ADDENDUM No. 1

Hoover Elementary School

2025 Stage Renovations

Arch. Project #240116

A2.0

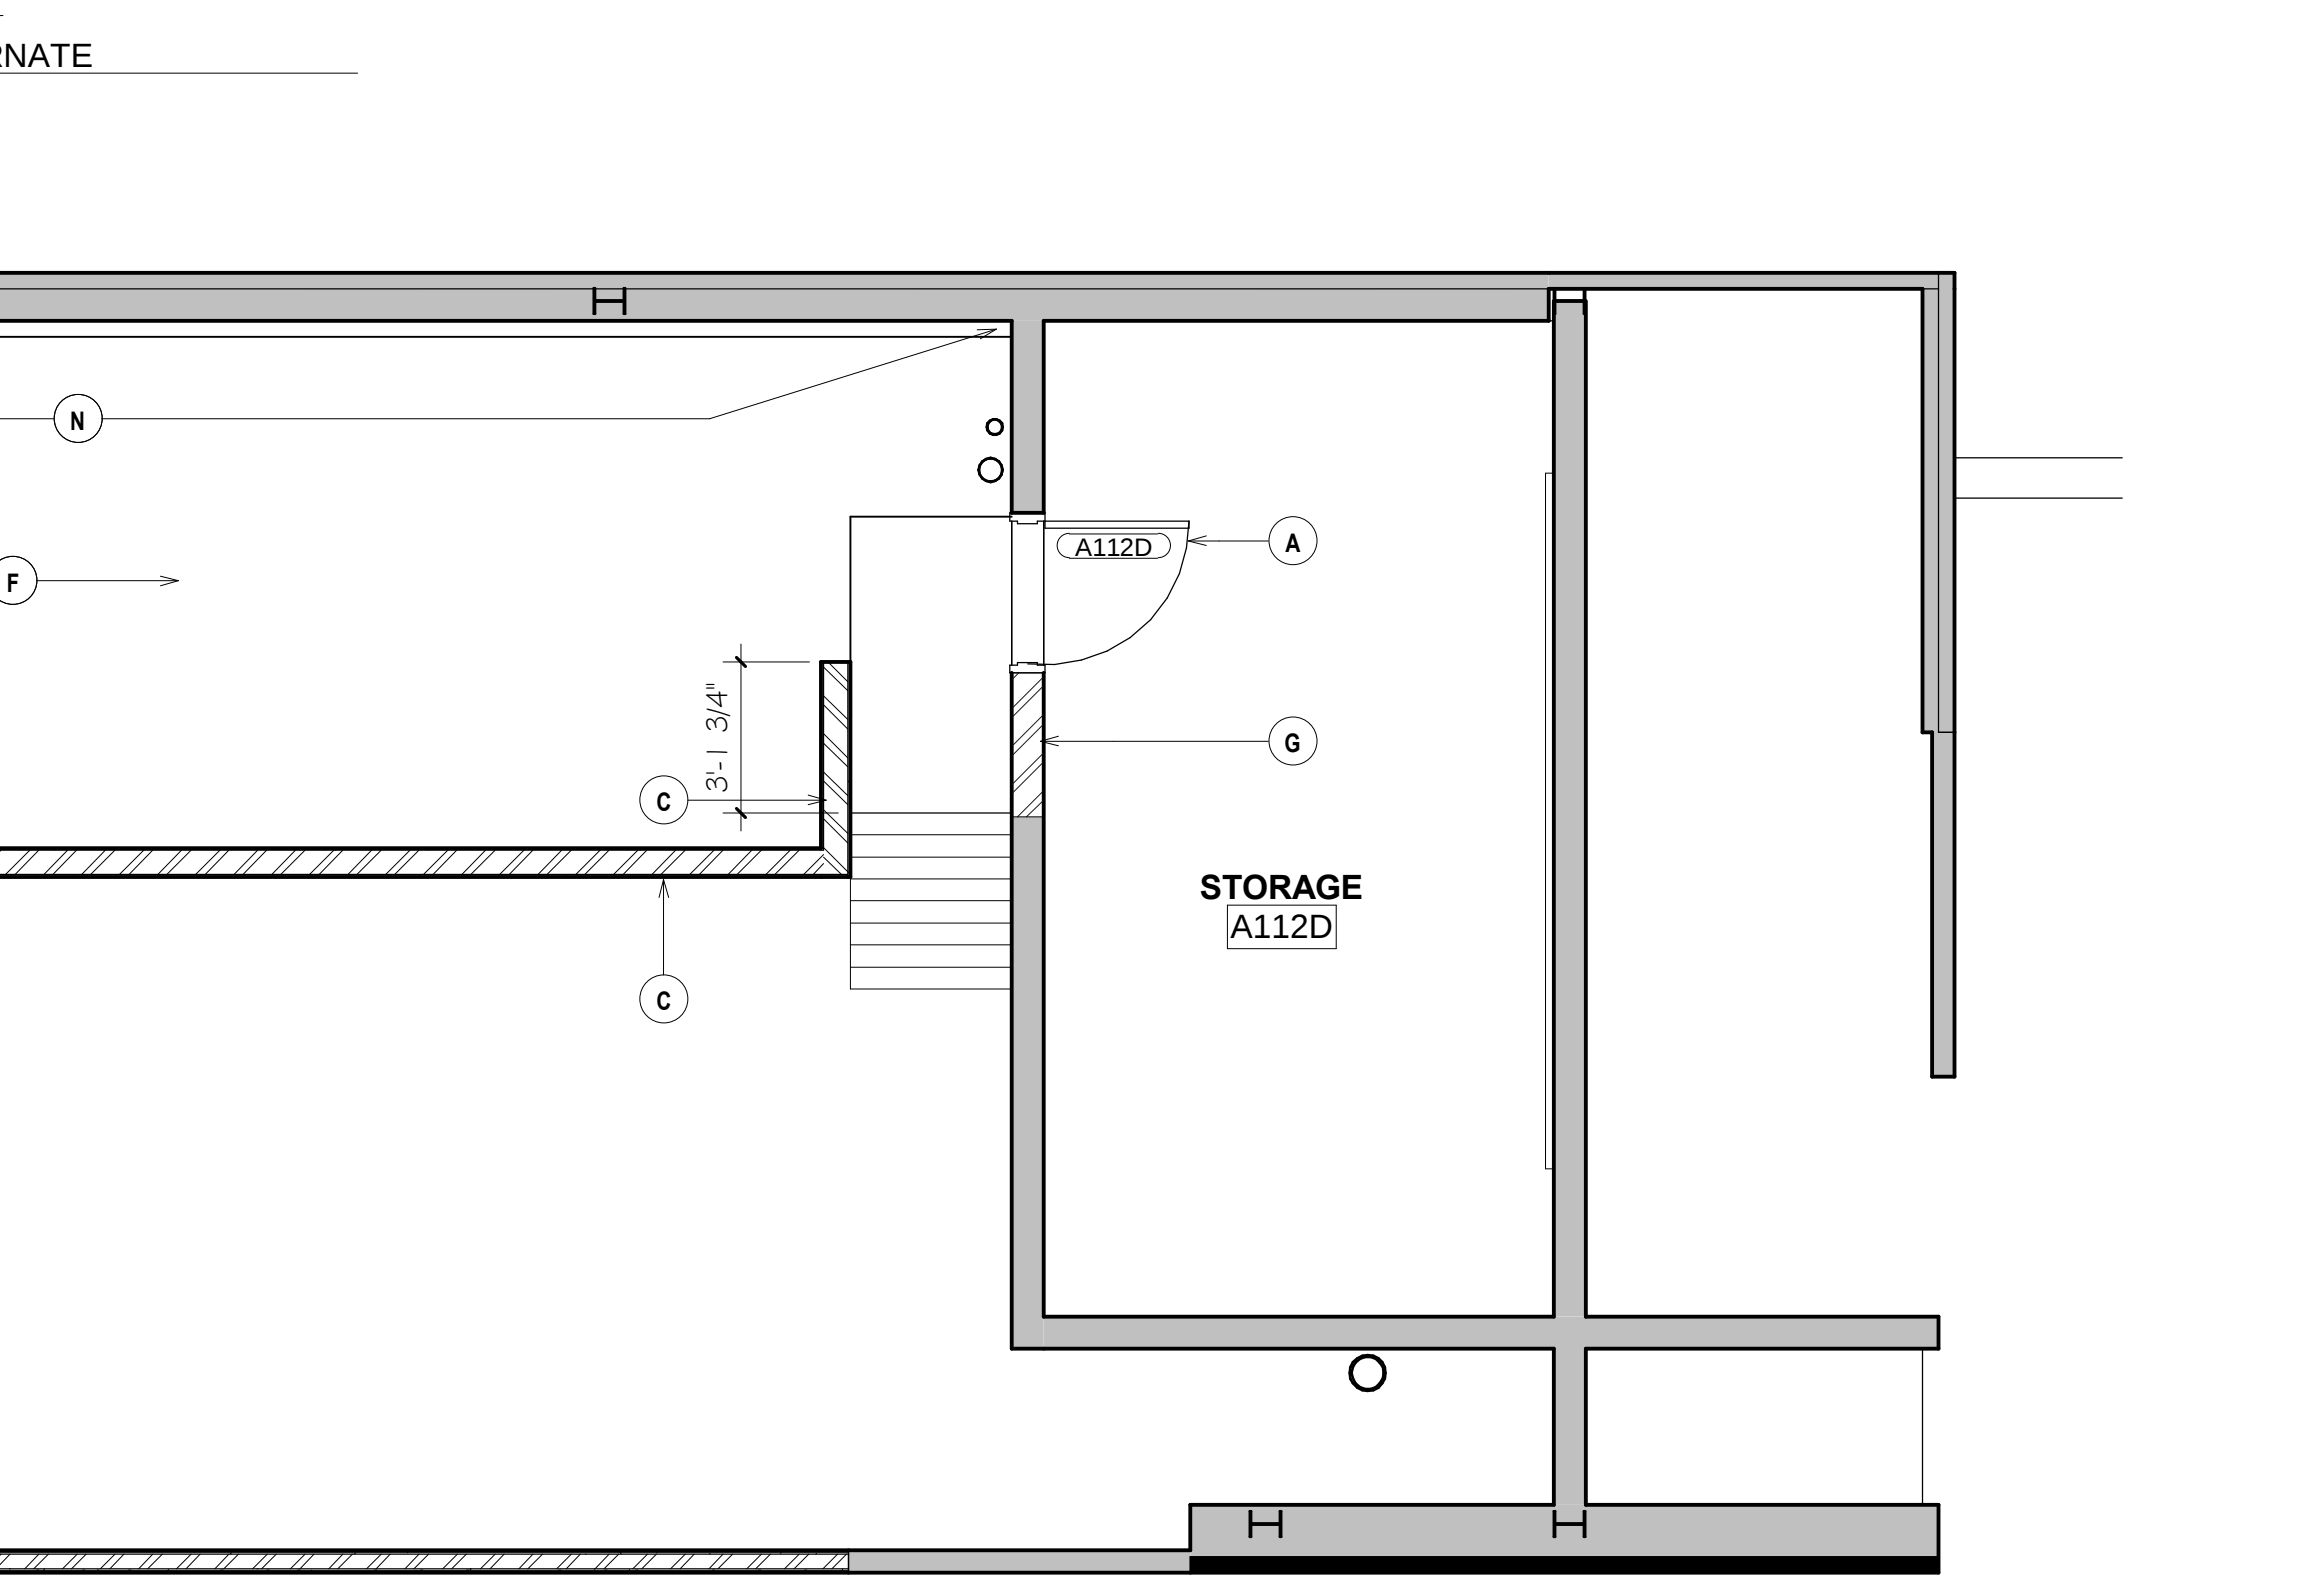
Sheet A2.0: Added section tags to 1/A2.0.
